UPGRADE OF 40-77B NOSE WHEEL ASSEMBLY TO 40-77G CONFIGURATION

- EFFECTIVITY:** Parker P/N 40-77B Nose Wheel Assemblies configured with wheel flange Style "A" as shown in Figure 1.
- APPLICABILITY:** The New Piper Aircraft Inc. Model PA46-500TP Meridian aircraft equipped with 40-77B Nose Wheel Assemblies having Style "A" flange configuration.

- REASON:** Product Upgrade - The New Piper Aircraft, Inc. has requested an upgrade in Nose Wheel from Model 40-77B to Model 40-77G. The 40-77G Nose Wheel is identical to 40-77B except for the use of a higher strength wheel tie bolts system. The result of this upgrade is improved service life of wheel tie bolts.

Figure 2

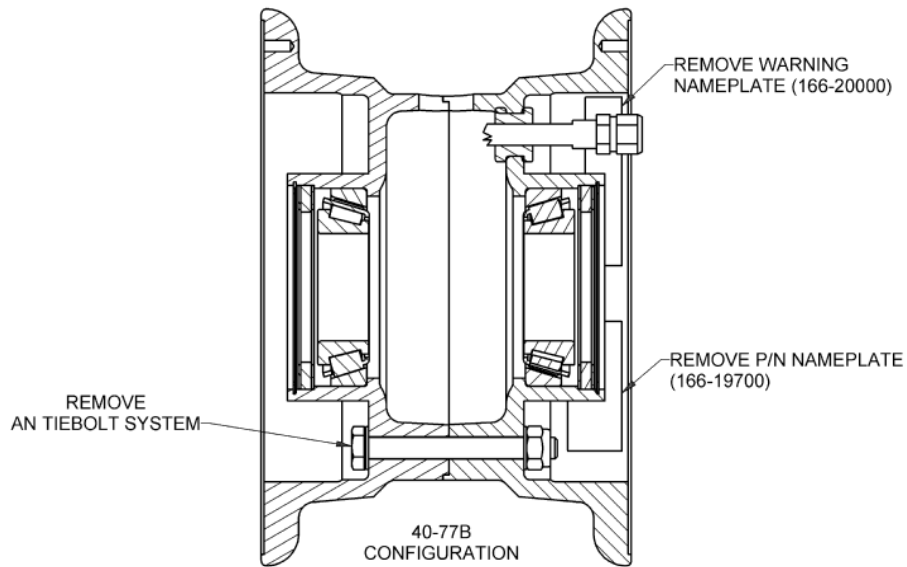
- 3) Disassemble wheel, remove and discard the wheel tie bolt hardware and nameplates listed in Table 2, below and as shown in Figure 2.

<u>Parker P/N</u>	<u>Description</u>	<u>Quantity</u>
103-10500	Bolt, (AN4-22A)	3
095-10200	Washer, (AN960-416L)	6
094-10300	Nut, (MS21044-N4)	3
166-19700	Nameplate, (P/N 40-77B Nose Wheel Assy)	1

Figure 3

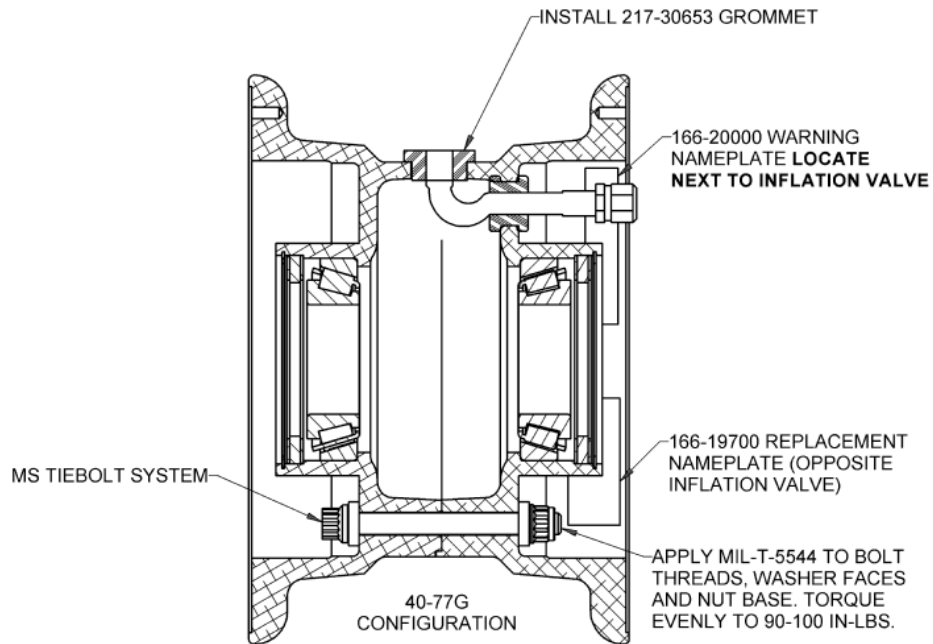
- 4) Apply anti-seize compound per AMS 2518 to bolt threads, washer faces, and nut base prior to assembly. Avoid getting anti-seize compound on wheel surfaces. Re-assemble the wheel-tire assembly with the hardware listed in SB7083-1 Upgrade Kit, (Table 1) IAW Parker AWBCMM0006 Component Maintenance Manual and as shown in Figure 3.

- 5) Restrain the bolt head and torque the nuts using a circular pattern. Torque the bolts evenly to 20 in-lb.
- 6) Torque the nuts evenly to 45-50 in-lbs (one half the final torque) starting with the next tie bolt.
- 7) Torque the nuts evenly to 90 in-lbs starting with the next tie bolt.
- 8) When all nuts are properly torqued to the value specified on the wheel nameplate or maintenance publication, clean the wheel using a non-residue cleanser / degreaser. Nameplates will not adhere to dirty or oily surfaces.
- 9) Excess amounts of anti-seize that squeeze out during torquing is normal and may be removed with a clean dry shop cloth and non-residue cleanser / degreaser.
